# UNITED STATES PATENT AND TRADEMARK OFFICE

APPLICATION NO.	FILING DATE	FIRST NAMED INVENTOR	ATTORNEY DOCKET NO.	CONFIRMATION NO.
10/824,185	04/14/2004	David Engebretson	391658003US1	5901
7590	05/04/2007			
David J. Engebretson President Comfort Design, Inc. 5110 River Road East Tacoma, WA 98443			EXAMINER	
			GILBERT, WILLIAM V	
			ART UNIT	PAPER NUMBER
			3635	
			MAIL DATE	DELIVERY MODE
			05/04/2007	PAPER

<b>Office Action Summary</b>	<b>Application No.</b>	<b>Applicant(s)</b>
	10/824,185	ENGBRETSON, DAVID
	<b>Examiner</b>	<b>Art Unit</b>
	William V. Gilbert	3635

**DETAILED ACTION**

Figure 2 from Cudini

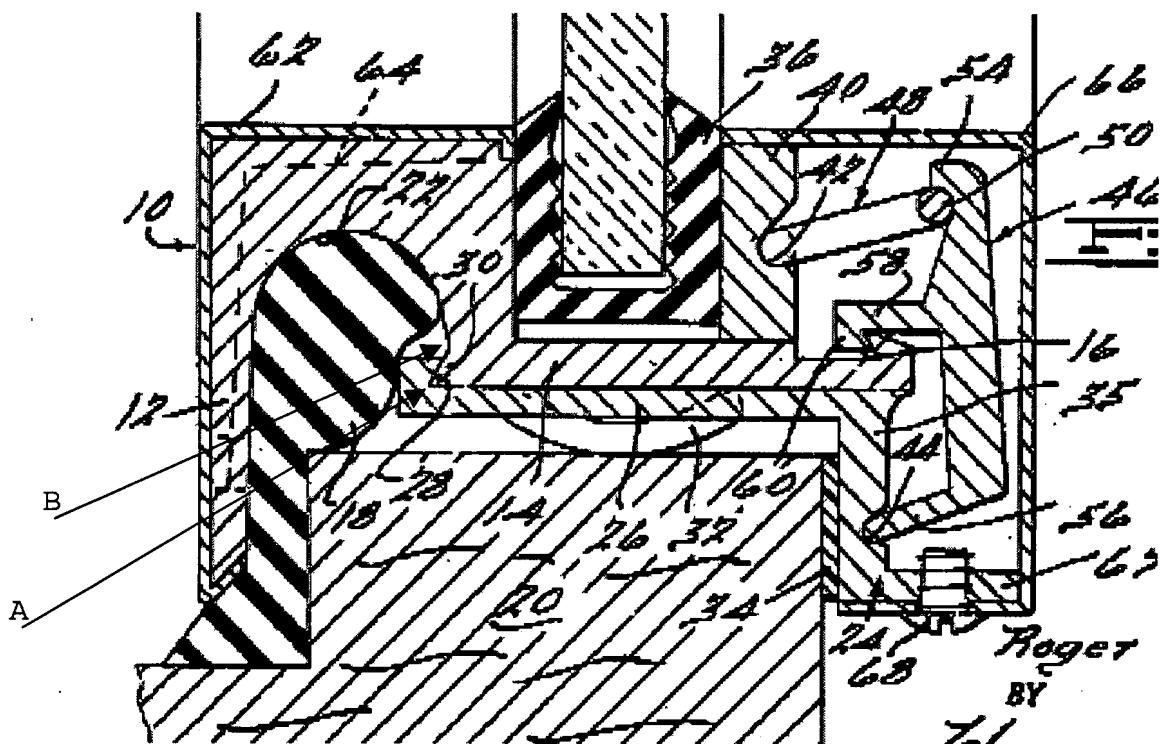
Claim 1: Cudini discloses a frame assembly comprising a cover (Fig. 2: 10) having a transverse member (14) and a face (proximate 28), the transverse member has first and second edges (see "A" and "B" respectively from attached Figure 2 from Cudini, below), inner and outer surfaces (proximate 14 and 22, respectively) the face is adjacent to the first edge, and the second edge tapers outwardly in a direction from the first edge to the second edge; a main frame (26) adapted to support a closure member (46) with respect to a frame opening (proximate

36), the frame having a confronting periphery (proximate 26) and an overhanging portion (24); a confronting edge (proximate "B", below) engages the second edge of the transverse member; a resilient support (18) engages an outer surface of the transverse member, and the resilient support is compressed by the transverse member as the member is moved toward the frame and the support is configured to urge the inner surface of the transverse member against the overhanging portion of the frame (proximate 35).

Claim 2: the resilient support member (18) is a compressible foam.

Claim 5: Cudini discloses a method of installing a window frame assembly comprising positioning a resilient support (18) with respect to a window housing (20), positioning a frame (26) having an opening, a confronting periphery (proximate 26) and an overhanging portion (24), positioning a cover (10) with respect to the window housing and frame, the cover has a transverse member (14) having a reduced thickness leading edge ("A" and "B" above) with a surface that tapers radially outward in a direction toward a cover; engaging at least a portion of the transverse member with the periphery (proximate 28) of the main frame and urging the cover toward the main frame to juxtapose at least a portion of the transverse member with the overhang of the main frame; the transverse member is compressing the resilient support.
